APPLICATION NO.	FILING DATE	FIRST NAMED INVENTOR	ATTORNEY DOCKET NO.	CONFIRMATION NO.
10/788,624	02/27/2004	Troy L. Cooper	17319	6525

Office Action Summary

Claims 1-3,5-7 are rejected under 35 U.S.C. 103(a) as being unpatentable over Bauer et al. (523,508) in view of Bucknam (1,663,239).

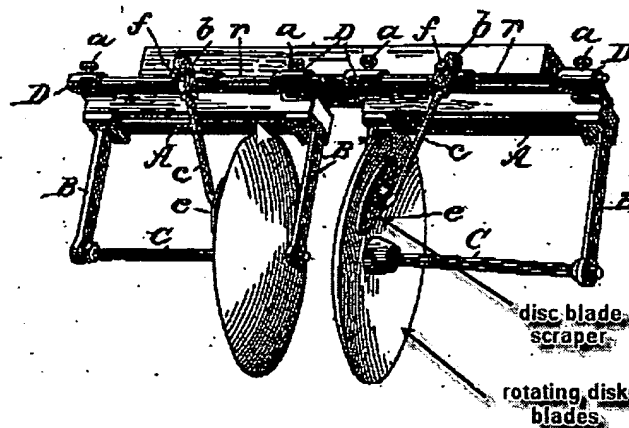
Bauer et al. discloses a disk blade scraper having a bracket (c) connected to the frame and a rotating disk (e) mounted to the bracket and having an axis of rotation and a circumference parallel to the axis of rotation. The bracket is connected to the frame and the rotating disk is mounted to the bracket such that the circumferential edge of the rotating disk is adjacent the transition joint of the disk (intersection of disks and shaft C). Bauer et al., however lacks showing the rotating disk blade including an annular depression relative to the concave surface, surrounding the transition joint.

Bucknam teaches that a disk blade including an annular depression surrounding the transition joint is an equivalent structure known in the art. Therefore, because these two disk blades were art-recognized equivalents at the time the invention was made, one of ordinary skill in the art would have found it obvious to substitute the disk blades of Bucknam for the disk blades of Bauer et al..

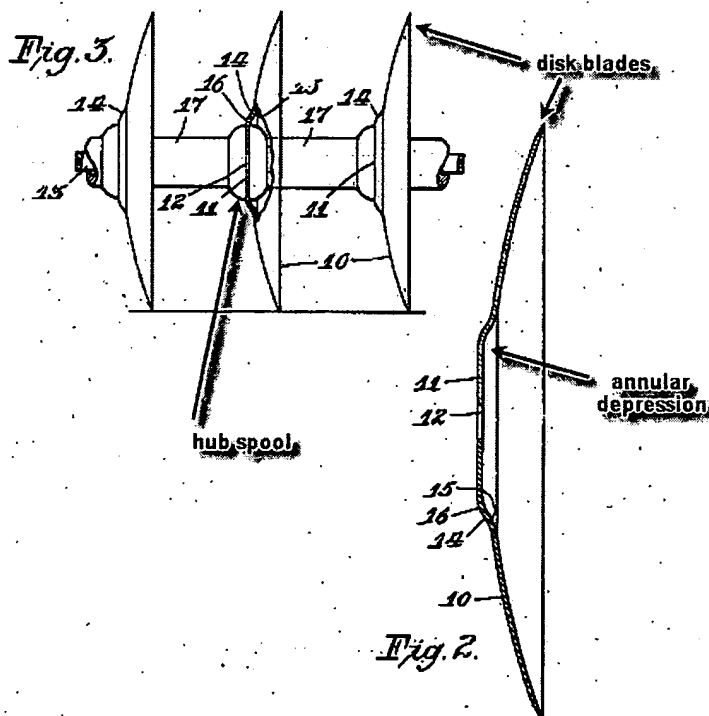
Claims 1-3,5-7 are rejected under 35 U.S.C. 103(a) as being unpatentable over Bucknam (1,663,239) in view of Bauer et al. (523,508).

Bucknam discloses a tillage implement including rotating disk blades arranged in laterally spaced relationship on a shaft, including a hub spool, transition joint and an annular depression. Bucknam however lacks a rotating disk blade scraper.

Bauer et al. teaches that it is known in the art to use a disk blade scraper with a tillage implement to keep the disk blades clean.

It would have been obvious to one of ordinary skill in the art at the time the invention was made to modify the device of Bucknam with rotating disk blade scrapers mounted to a bracket connected to a frame as taught by Bauer et al., to keep the disk blades of Bucknam clean.
